ATTACHMENT (1)

UNIT 1

TECHNICAL SPECIFICATION

REVISED PAGES

FIGURE 3.4.9-1

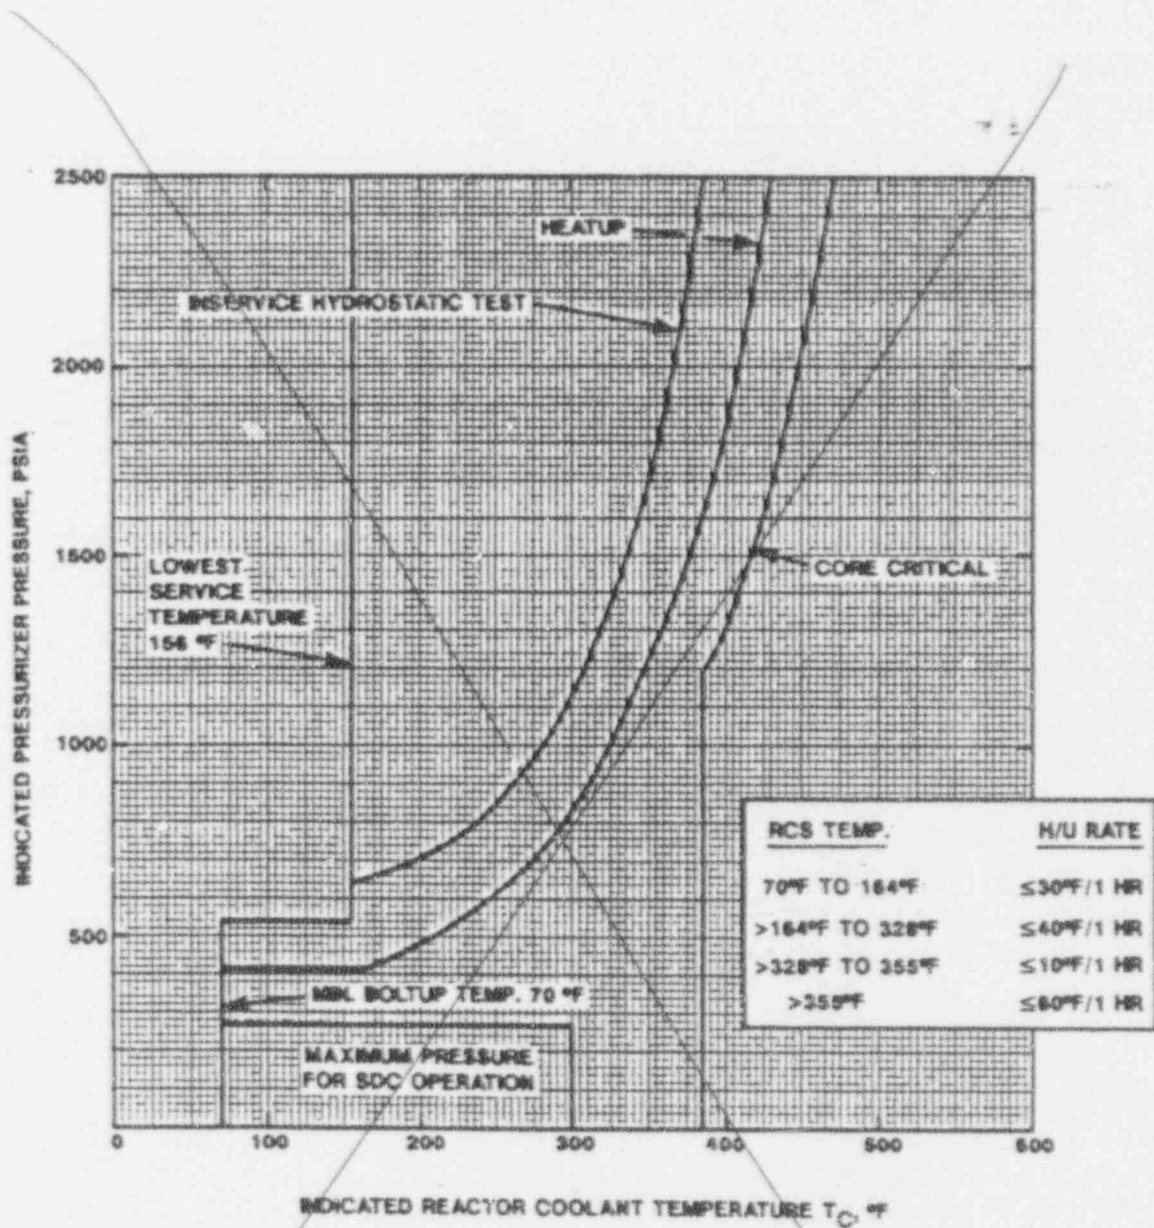
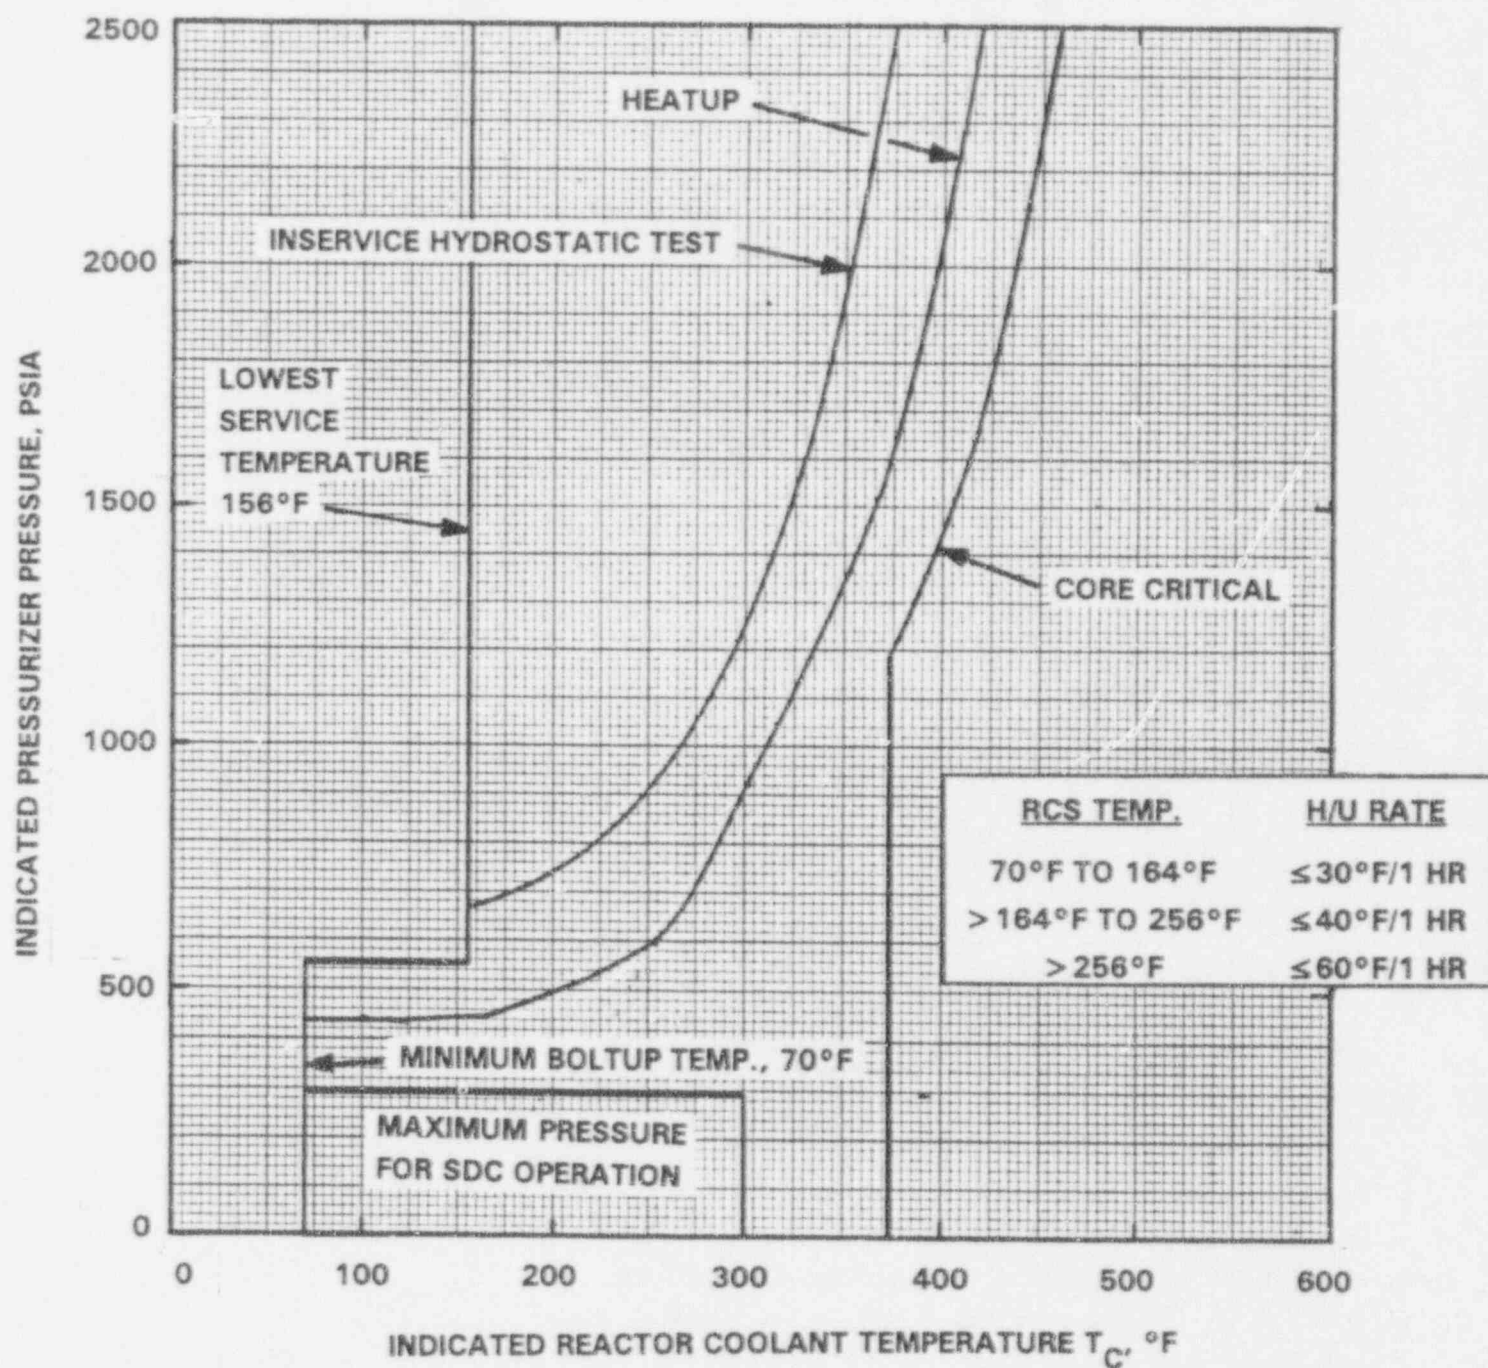
CALVERT CLIFFS UNIT 1 HEATUP CURVE
 REACTOR COOLANT SYSTEM PRESSURE TEMPERATURE LIMITS
 FOR FLUENCE $\leq 3.25 \times 10^{18}$ n/cm² AT THE INNER SURFACE OF THE REACTOR VESSEL

CALVERT CLIFFS UNIT 1 HEATUP CURVE
 REACTOR COOLANT SYSTEM PRESSURE TEMPERATURE LIMITS
 FOR FLUENCE $\leq 2.61 \times 10^{19}$ n/cm² AT THE INNER SURFACE OF THE REACTOR VESSEL

FIGURE 3.4.9-2

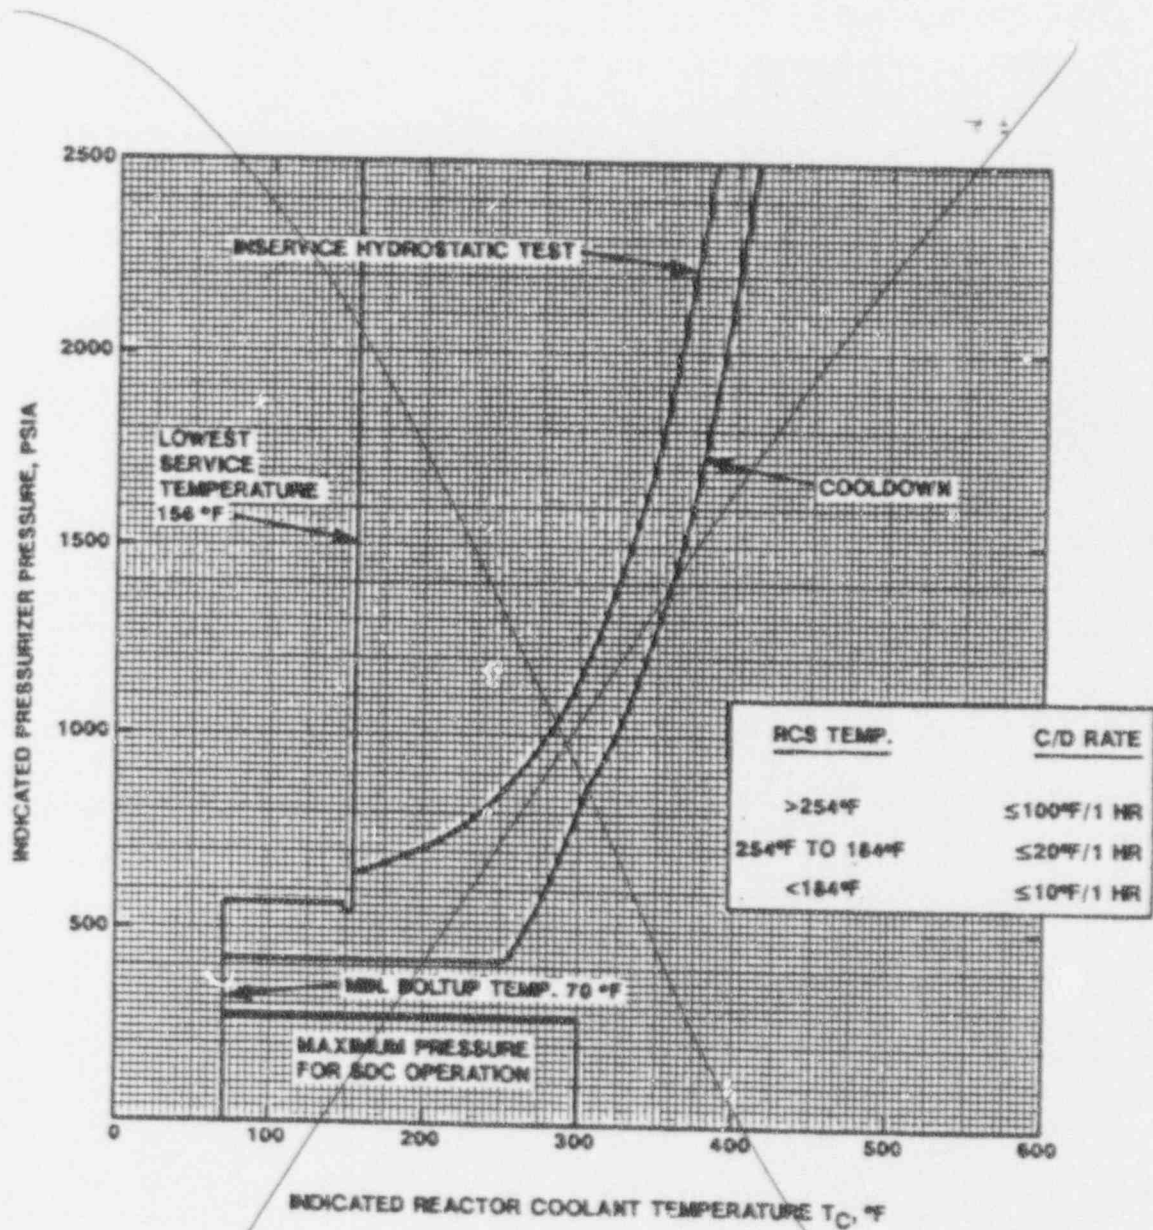
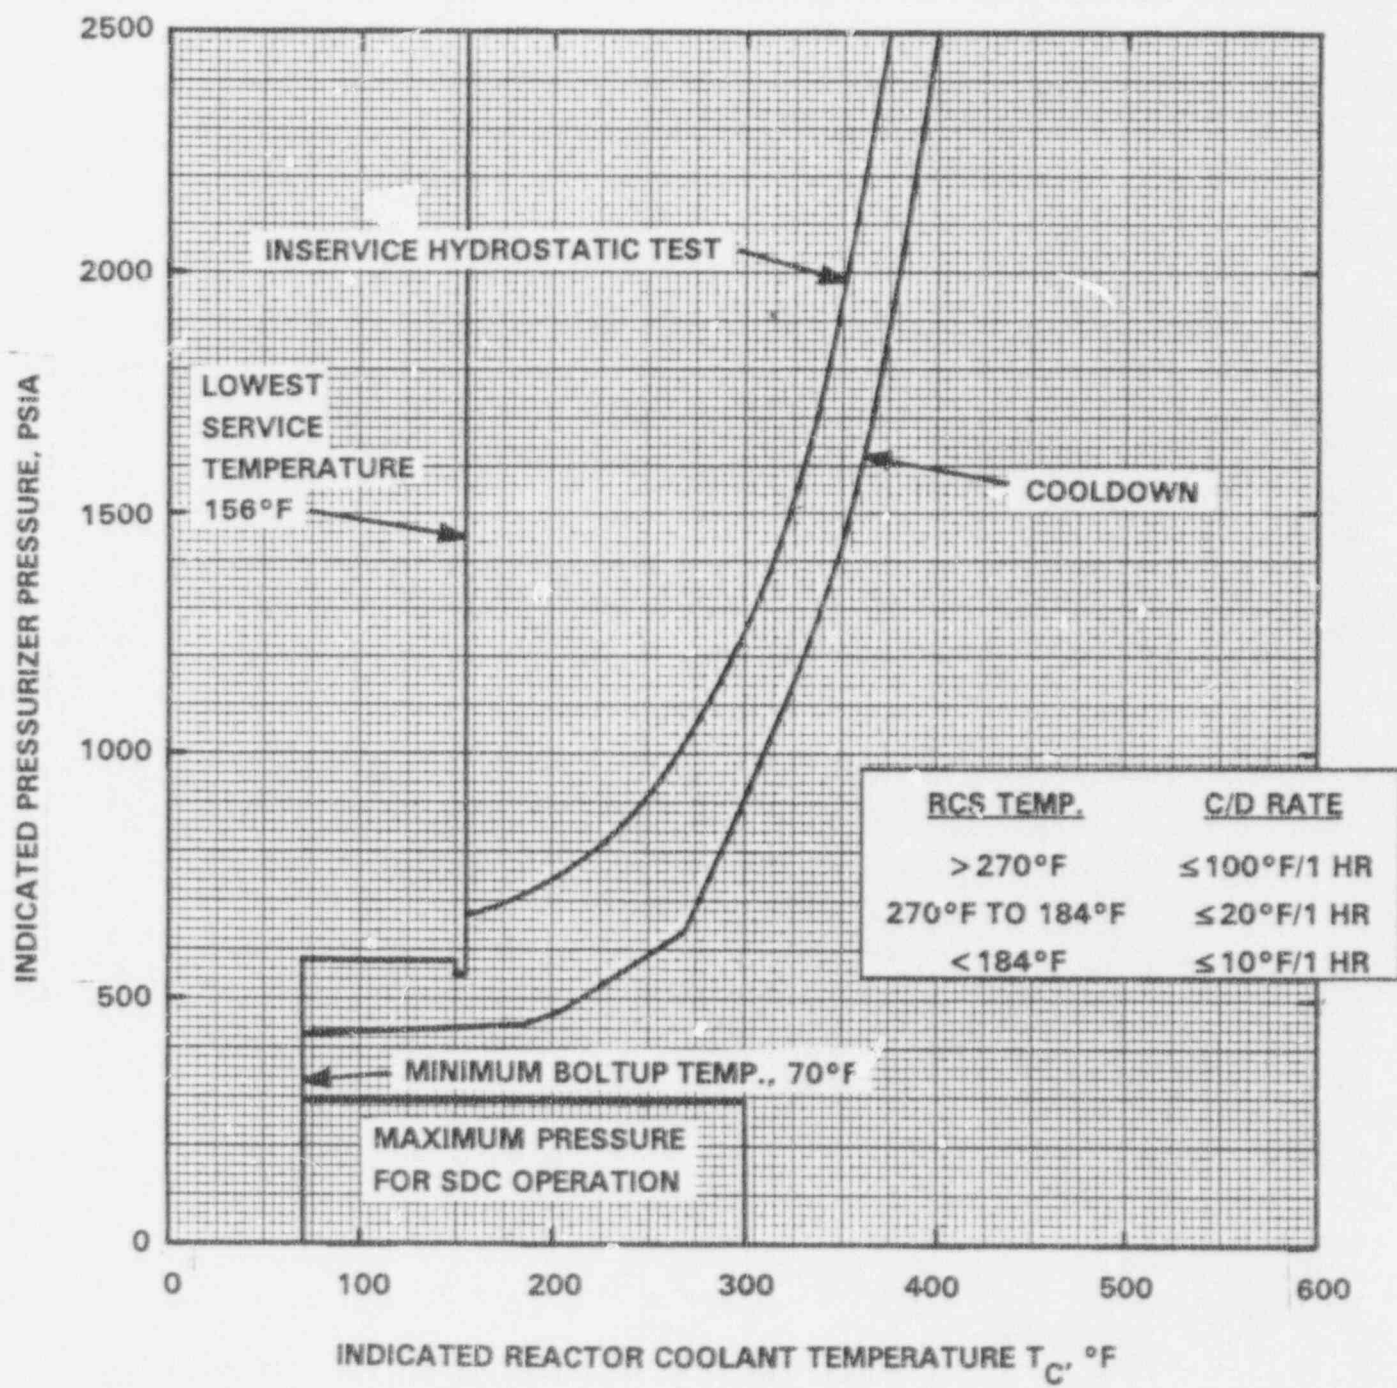
Replace

CALVERT CLIFFS UNIT 1 COOLDOWN CURVE
 REACTOR COOLANT SYSTEM PRESSURE TEMPERATURE LIMITS
 FOR FLUENCE $\leq 3.25 \times 10^{18}$ n/cm² AT THE INNER SURFACE OF THE REACTOR VESSEL

CALVERT CLIFFS UNIT 1 COOLDOWN CURVE
 REACTOR COOLANT SYSTEM PRESSURE TEMPERATURE LIMITS
 FOR FLUENCE $\leq 2.61 \times 10^{19}$ n/cm² AT THE INNER SURFACE OF THE REACTOR VESSEL

FIGURE 3.4.9-3

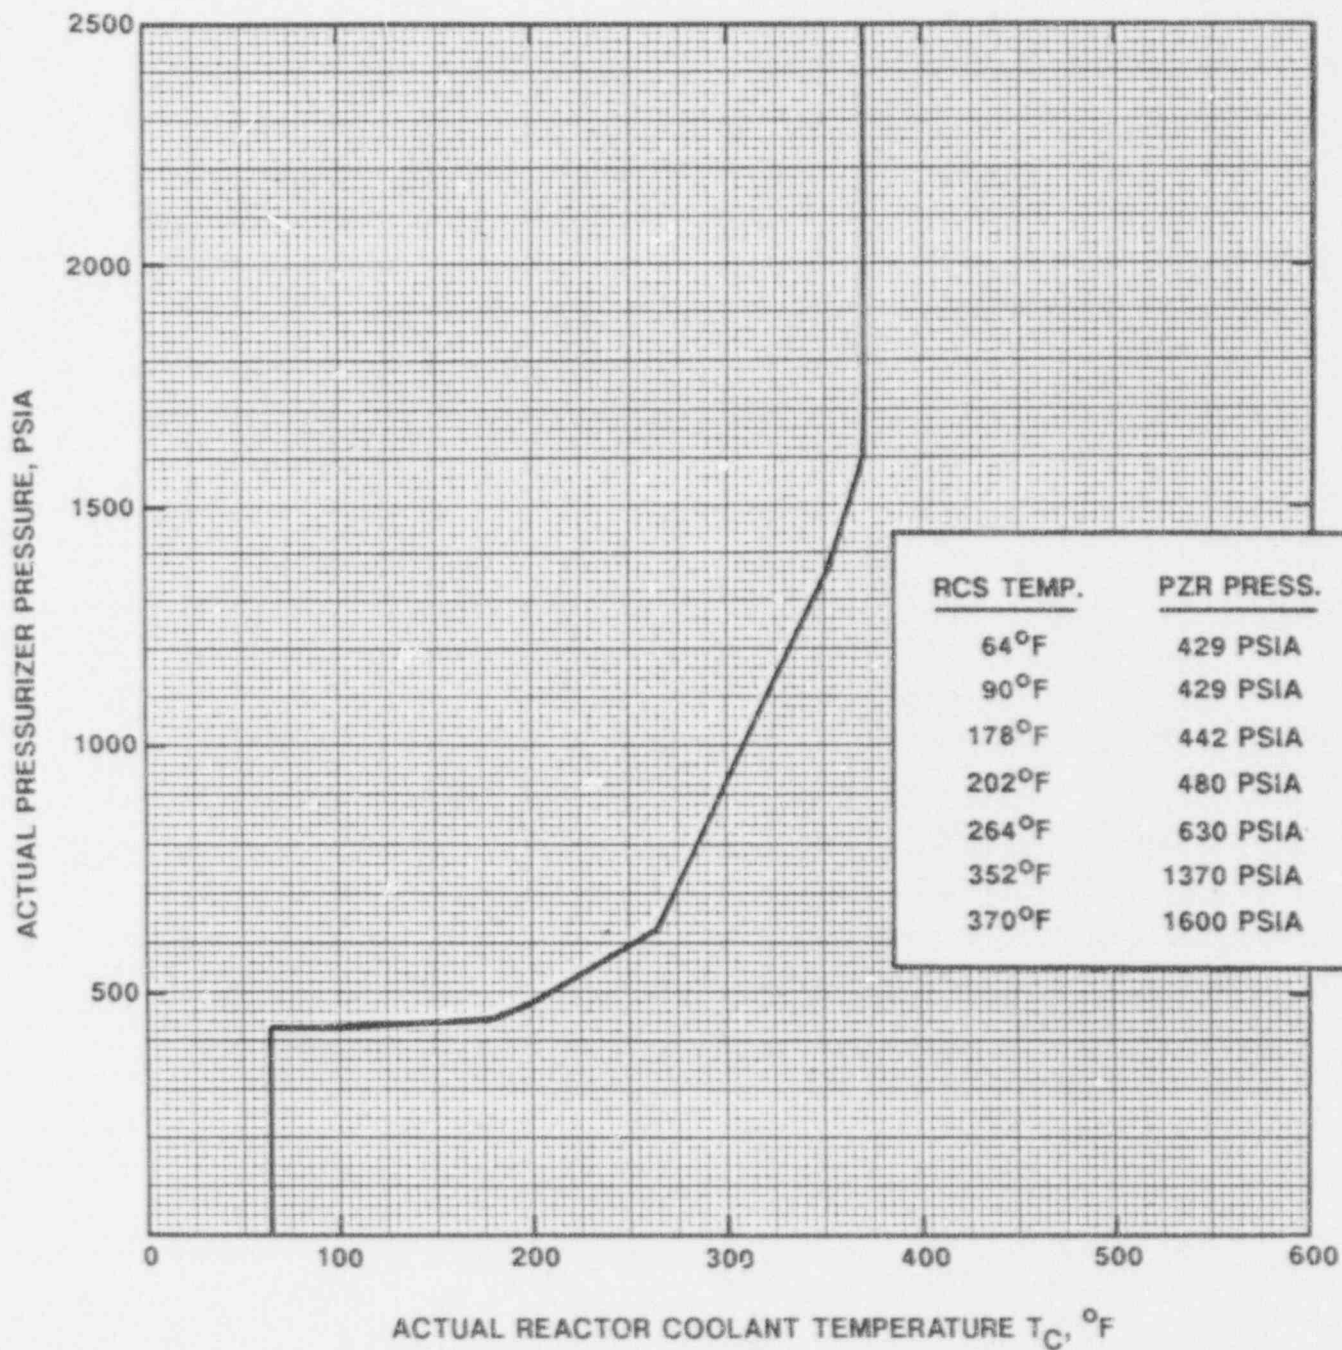
- a. One of the following three Overpressure Protection Systems shall be in place:
 1. Two power-operated relief valves (PORVs) with a trip setpoint ~~≤ 429 psia~~ or *below the curve in Figure 3.4.9-3**

** When ON Shutdown Cooling, the PORV trip setpoint shall be ≤ 429 psia*

The PORV setpoint is chosen to protect the most limiting of the heatup or cooldown Appendix G limits. Figure 3.4.9-3 shows the maximum PORV opening pressure. This includes corrections for static and dynamic head, and pressure overshoot to account for PORV response time and the maximum pressurization rate. The actual PORV setpoint is controlled by procedure and accounts for device uncertainty, calibration uncertainty and loop drift.
